CABINET MEMBER FOR ENVIRONMENT – 10 MAY 2018

DIDCOT: B4493 WANTAGE ROAD – PROPOSED CYCLE PROVISION

Report by Director for Infrastructure Delivery

CMDE5

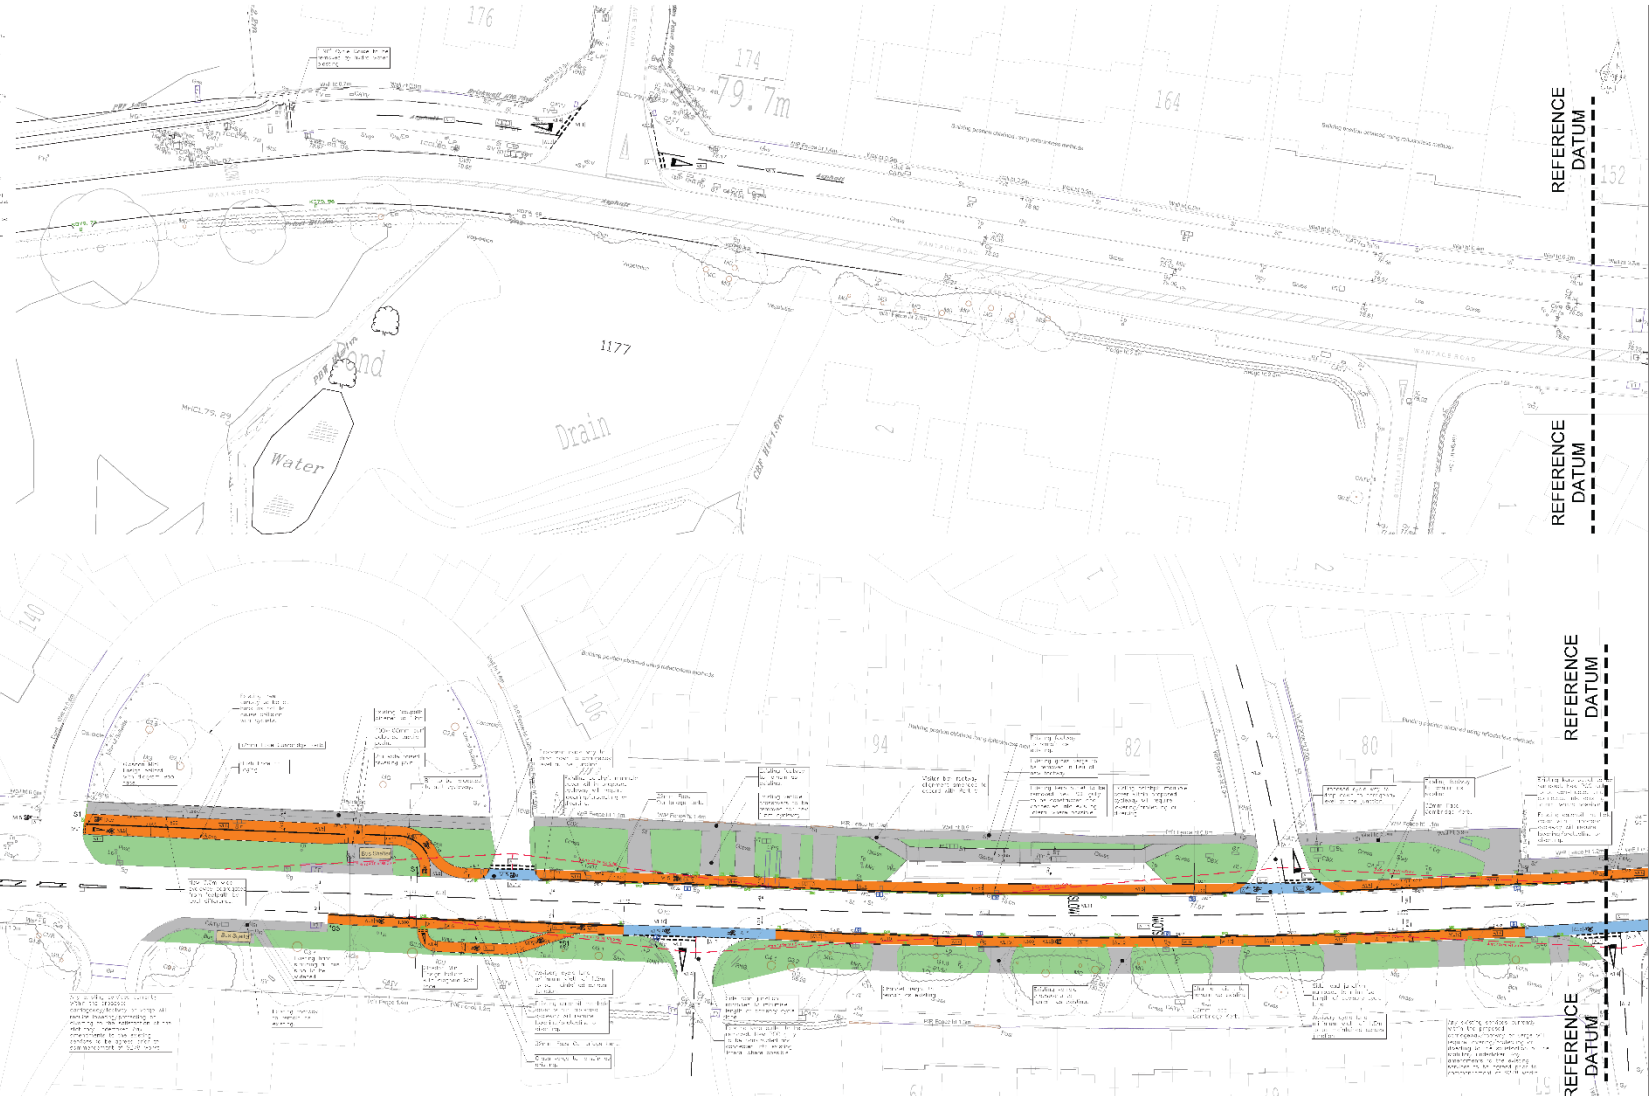
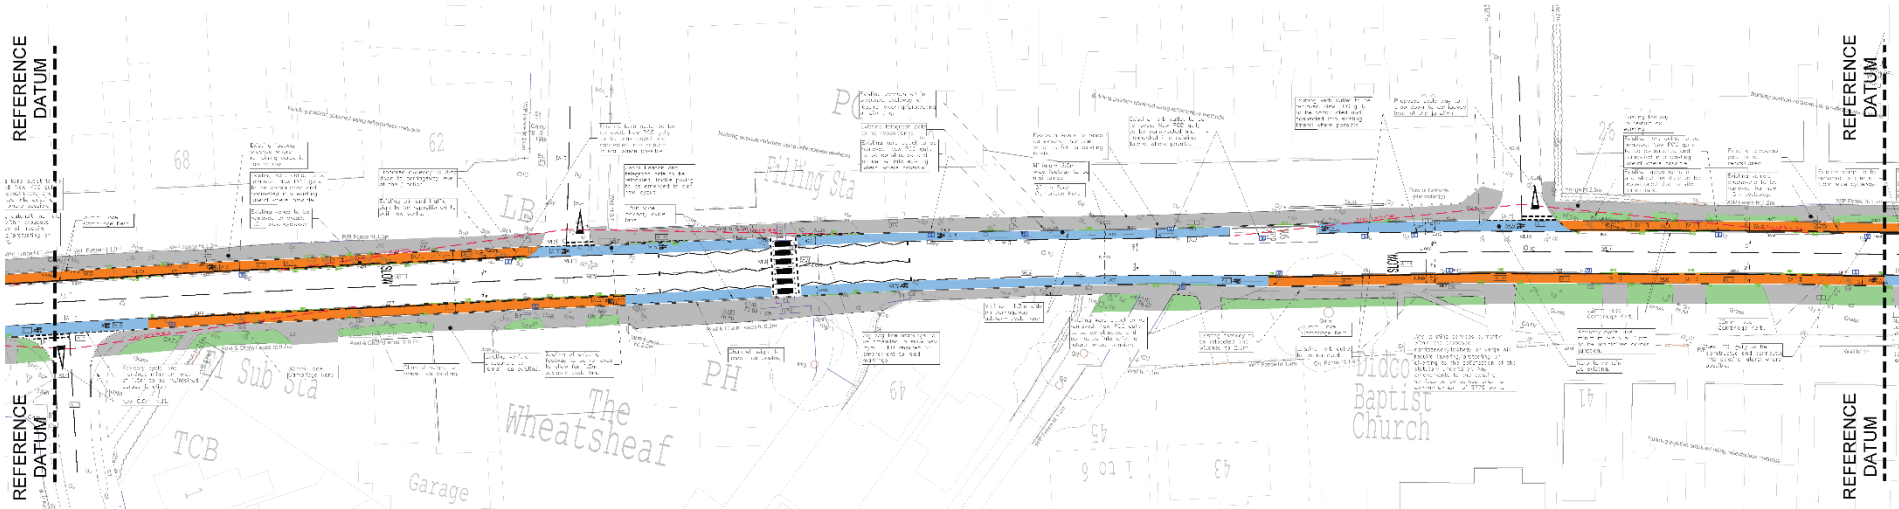
(4) Assistant Tree Officer, (South & Vale District Council)	Neither - the proposed cycle route is within close proximity to a mature oak tree (shown as G3.0 on the plan) located to the south of the road. Currently the area around this tree is grass verge and therefore excavation this close to the tree is likely to lead to root damage to the tree. Therefore it is recommended that this part of the cycle route is amended to give greater clearance to the tree.

<p>2) The section around the zebra crossing where the road narrows has advisory lanes only, they can be driven in when required. As such there is no need at all to reduce the cycle lane width at this point to 1.3m as cars can simply encroach on the lane when no cyclists are present. Narrowing the cycle lane will only serve to encourage cars to pass cyclists at this point even though the carriageway is too narrow to maintain a safe distance. This lane width also contravenes the Oxfordshire cycle design guidance. 1.8m advisory lanes should be the standard through this section.</p> <p>3) The end of the stepped lane at the western edge should transition to a mandatory lane and then an advisory one before terminating. The current layout looks like a very short transition period.</p> <p>4) The Oxfordshire cycling design guidance recommends a cycle lane width of 1.8m (1.5m being the absolute minimum). Why is this recommendation ignored for this scheme? The road is wide and there is substantial space available along most of the route on the grass verge to provide the recommended width. The bulk of this route should be 1.8m wide. This scheme is supposed to encourage an increase in cycling and, with a huge number of new houses being built along the route, the design has to accommodate the increase in numbers expected.</p>

(41) Local Resident, (Wantage Road, Didcot)	<p>Object - in trying to make improvements for cyclists, this revised scheme could create more danger for motorists and there will still be potential danger for pedestrians too, especially the sections coloured dark blue on the plans, marked 'advisory cycle route', which I think could cause confusion. There are lengthy 'advisory' sections on both sides of the route and it is not clear how cyclists will leave and re-join the alternating stretches of cycle route and 'advisory' cycle route. This could cause a lot of confusion and dangerous cycling/driving situations.</p> <p>Even on the red 'proposed cycle route' section from Georgetown Roundabout to Manor Crescent, there will still be a danger to many school children walking this route to and from school every day.</p> <p>In the 'advisory' area outside the shopping parade from numbers 30 to 50 there will be the danger of kerbside parked cars (and a bus stop), with vehicle doors opening onto on-coming cyclists. There is also an entrance and exit to the BP petrol station, entrance/exit to a Sainsbury's store and many other businesses, together with busy road junctions to three entrances to Didcot Girls' School, all of which make this a very busy road.</p> <p>I think that the density of cars on this road, combined with the facts that this road is not a particularly wide road (even taking into consideration the proposed removal or narrowing of some of the grass verges and pavements) and the alternating section of cycle route and 'advisory' cycle route, will make the road more hazardous and will also cause confusion as to priorities for motor vehicles, pedal cycles and pedestrians. At least, at present, all users have clear and equal priorities.</p> <p>As a regular cyclist on Wantage Road it is my opinion that it is best for cyclists to continue to use the road in the usual manner. I know it is a busy road, but there are plenty of other busy roads in Didcot. In my opinion, Wantage Road does not lend itself to have cycle lanes because of the number of busy business premises and road junctions which open onto the road and the confusion and danger that I think will be caused by the 'advisory' sections of the proposed route.</p>

9. Clarification was requested regarding the dimensions of certain sections in the proposed cycleway design. The width of the cycleway is 1.5m along the whole of the proposed scheme. This complies with Sustrans and Oxfordshire County Council's Cycling Design Standards to ensure a high quality and accessible route for cyclists is created.

17. The Assistant Tree Officer (South & Vale District Council) has raised a concern about a mature oak tree and potential for root damage. The design will take into account mature trees and root damage will be avoided by either

amending the scheme or using sensitive construction methods. The County Council will continue to liaise with the Tree Officer.

21. The scheme, therefore, proposes to widen the overall carriageway to better accommodate different modes. The width of the road for the most part will be 6m for general traffic. This is reduced to 5.5m at the advisory cycle lanes at Wantage Road shops. However, vehicles are permitted to enter advisory cycle lanes when necessary – so although the general traffic space reduces to 5.5m, as the advisory cycle lanes can be entered, the available space is actually 8.1m. This is not uncommon on existing roads and in fact occurs in Oxford where it could be argued that more buses/larger vehicles are likely to encounter each other as opposing traffic than on the Wantage Road. The use of cycle lanes to discourage parking will help the flow of traffic and benefit bus operation. Buses currently pass cyclists with care, by slowing down to manoeuvre around them. These proposals enhance this position by providing cyclists with their own space, reducing the extent needed for buses and other
